ATTACHMENT 6

Dresden Station Unit 2

DPR-19

Proposed Technical Specifications

Figure 3.5-2 (Sheet 1 of 2) MCPR Limit for Reduced Core Flow

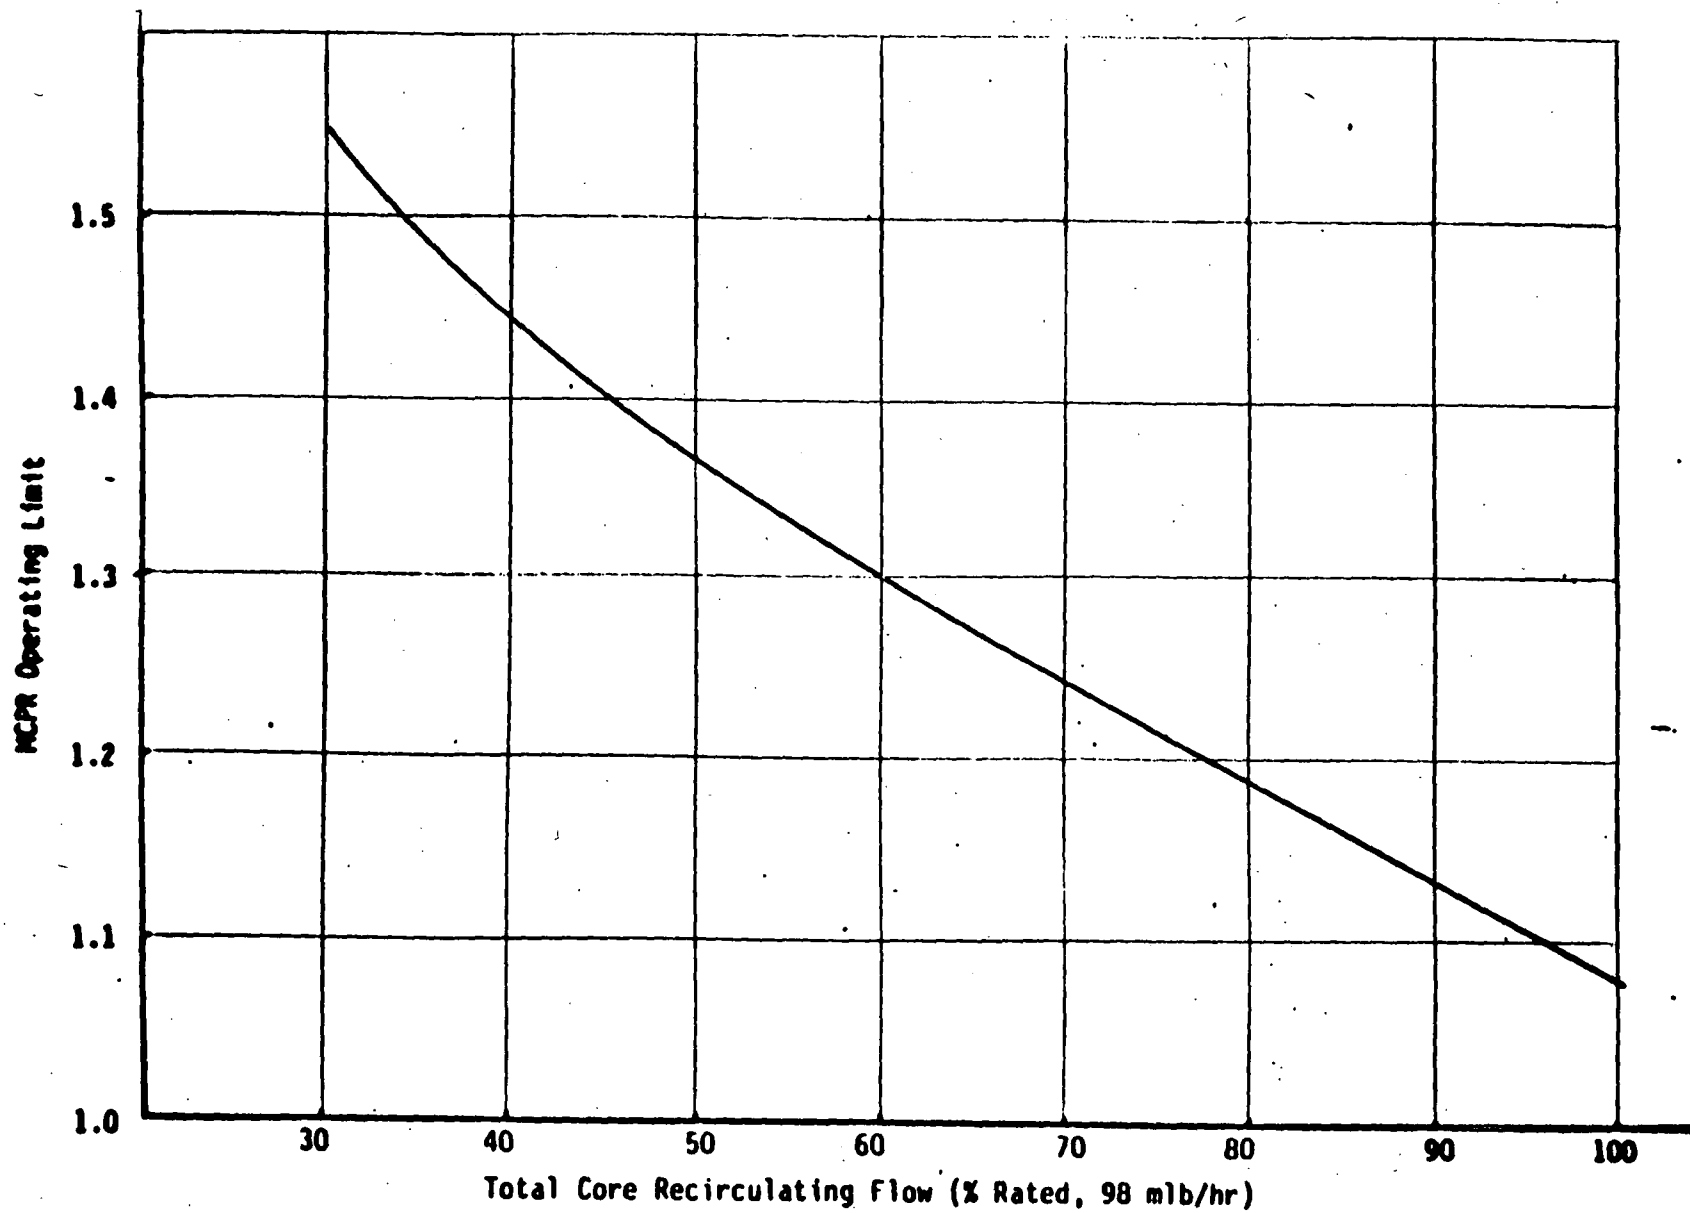
1. Manual Flow Control-the MCPR Operating Limit shall be the value from Figure 3.5-2 sheet 1 or the above rated core flow value, whichever is greater.
2. Automatic Flow Control-the MCPR Operating Limit shall be the value from Figure 3.5-2 Sheet 1, Sheet 2 or the above rated core flow value, whichever is greatest.

Figure 3.5-2 (Sheet 2 of 2) MCPR Limit for Automatic Flow Control

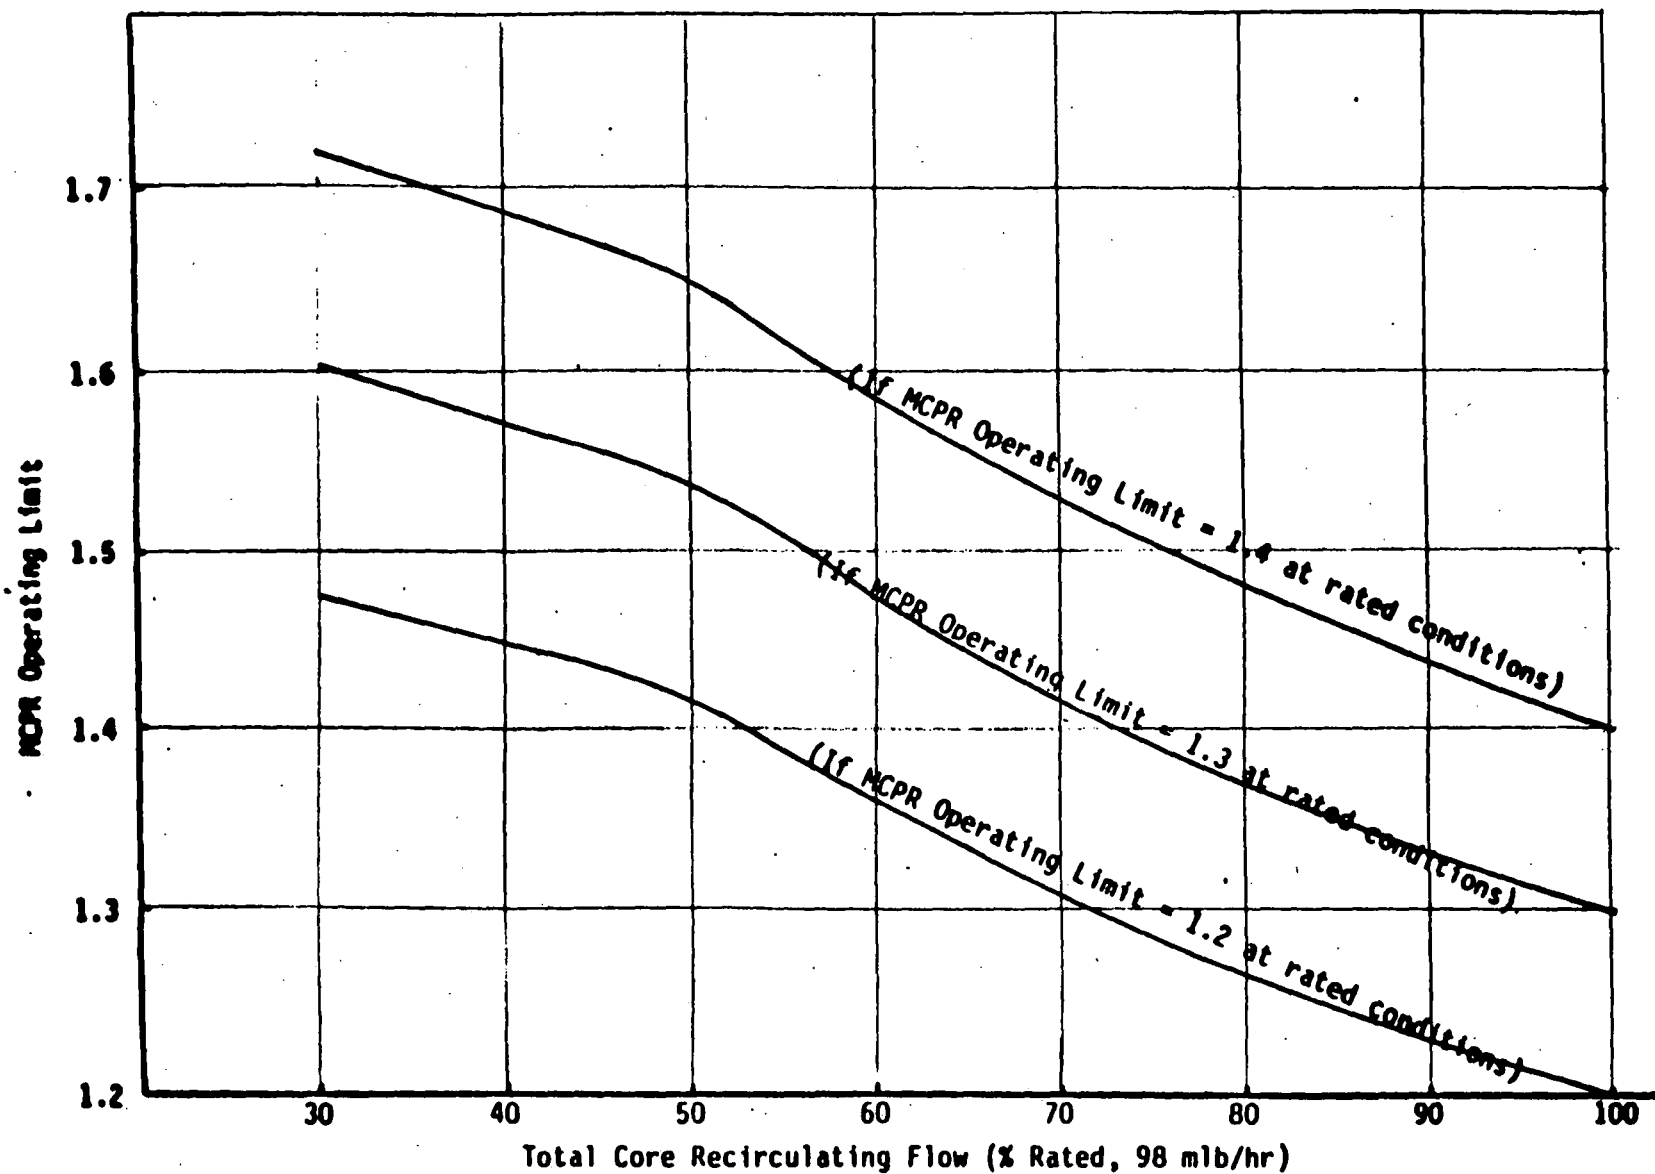
Therefore, for Automatic Flow Control, the MCPR Operating Limit is chosen as the value from Figure 3.5-2 Sheet 1, Sheet 2 or the rated flow value, whichever is greatest. It should be noted that if the rated flow MCPR Limit must be increased due to degradation of control rod scram times during the current cycle, the new value of the rated flow MCPR limit is applied when using Figure 3.5-2 Sheet 2.
